# UNITED STATES PATENT AND TRADEMARK OFFICE

APPLICATION NO.	FILING DATE	FIRST NAMED INVENTOR	ATTORNEY DOCKET NO.	CONFIRMATION NO.
10/092,767	03/07/2002	Dieter Kress	2146.GLE.PT	8734

## Office Action Summary

## **DETAILED ACTION**

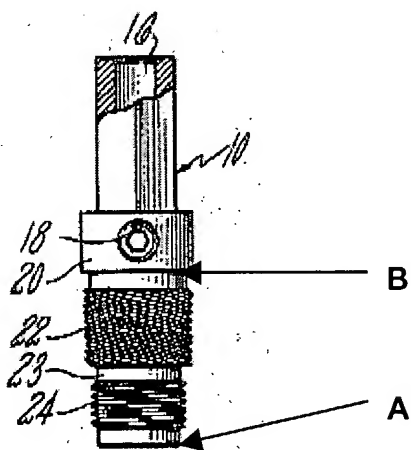
As to claim 6, Bittern discloses a device for connecting two tool parts **12,14** configured for receiving a threaded spindle, each of the tool parts having an associated threaded area, and wherein the device comprises:

a threaded spindle **10** having a projecting shoulder **A** (Figure reprinted below with annotations), the outside diameter of which is slightly smaller than the interior diameter of the associated threaded area of one of the tool parts **12** to approximate the interior diameter such that the projecting shoulder serves to guide the threaded spindle into, and provide axial and angular alignment between, the two tool parts, the projecting shoulder having an axially positioned tool-receiving element (side wall of projecting shoulder **A** receives tool part **14**) to effect rotation of the threaded spindle (axially aligning the insertion of projection shoulder **A** within tool parts **12,14**; thus effecting the rotation of the threaded spindle) when the projecting shoulder is inserted within a tool part.

As to claim 7, Bittern discloses a device wherein a threaded spindle **10** has a projecting shoulder **A,B,23** at each end.

As to claim 8, Bittern discloses a device wherein the outside diameter of a projecting shoulder **A,B,23** at each end is slightly smaller than the interior threads of an associated threaded area of a corresponding tool part **12,14** to approximate the interior threads thereof to guide a threaded spindle **10** into, and provide axial and angular alignment between, the two tool parts.

As to claim 9, Bittern discloses a device wherein a threaded spindle **10** has two threaded sections **22,24**, each being threaded in a direction opposite the other and assigned to corresponding threaded areas of tool parts **12,14**.

As to claim 10, Bittern discloses a device wherein threaded sections **22,24** of a threaded spindle **10** have differing outside diameters for being correspondingly adapted to the differing interior diameters of two tool parts **12,14**.

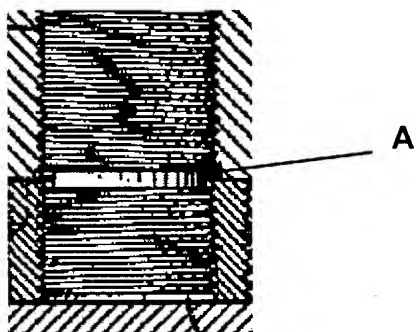
As to claim 6, Sanderson discloses a device for connecting two tool parts **1,2,4** configured for receiving a threaded spindle, each of the tool parts having an associated threaded area, and wherein the device comprises:

a threaded spindle **3** having a projecting shoulder **7**, the outside diameter of which is slightly smaller than the interior diameter of the associated threaded area of one of the tool parts **1** to approximate the interior diameter such that the projecting shoulder serves to guide the threaded spindle into, and provide axial and angular alignment between, the two tool parts, the projecting shoulder having an axially

positioned tool-receiving element **10** to effect rotation of the threaded spindle when the projecting shoulder is inserted within a tool part (Figures 1 and 7).

As to claim 7, Sanderson discloses a device wherein a threaded spindle **10** has a projecting shoulder **7,A** at each end (Figure 1 reprinted with annotations below).

As to claim 8, Sanderson discloses a device wherein the outside diameter of a projecting shoulder **7,A** at each end is slightly smaller than the interior threads of an associated threaded area of a corresponding tool part **1,2,4** to approximate the interior threads thereof to guide a threaded spindle **3** into, and provide axial and angular alignment between, the two tool parts (Figure 1).

As to claim 9, Sanderson discloses a device wherein a threaded spindle **3** has two threaded sections **5,6**, each being threaded in a direction opposite the other and assigned to corresponding threaded areas of tool parts **1,2,4** (Figure 1).

a threaded spindle **3** having a first threaded sections **5** for engaging the threaded area of the first tool piece and a second threaded section **6** for engaging the threaded area of the second tool piece, and wherein the threaded spindle has a shoulder **7** extending beyond one of the threaded sections, the projecting shoulder having an outer diameter slightly smaller than the interior diameter of the threaded area of the first tool piece for approximating the interior diameter of the threaded area to thereby guide the threaded section into the threaded area and provide axial and angular alignment of the first and second tool pieces, the projecting shoulder having a tool-receiving portion for effecting rotation of the threaded spindle via the projecting shoulder when inserted in the first or second tool piece (Figures 1 and 7).

As to claim 13, Sanderson discloses a connection wherein a second tool piece **2,4** partially nests within a first tool piece **1** (Figure 1).

As to claim 14, Sanderson discloses a connection wherein a threaded spindle **3** has a opposing ends and has a projecting shoulder **7,A** at each end (Figure 1).

As to claim 15, Sanderson discloses a connection wherein the outside diameter of each projecting shoulder **7,A** at each end is slightly smaller than the interior threads of an associated threaded area of a corresponding tool piece **1,2,4** to approximate the interior threads to guide a threaded spindle **3** into place and to provide axial and angular alignment between first and second tool pieces **1,2,4** (Figure 1).

As to claim 16, Sanderson discloses a connection wherein threaded sections **5,6** of a threaded spindle **3** have opposing orientations and are assigned to corresponding threaded areas of tool pieces **1,2,4** (Figure 1).
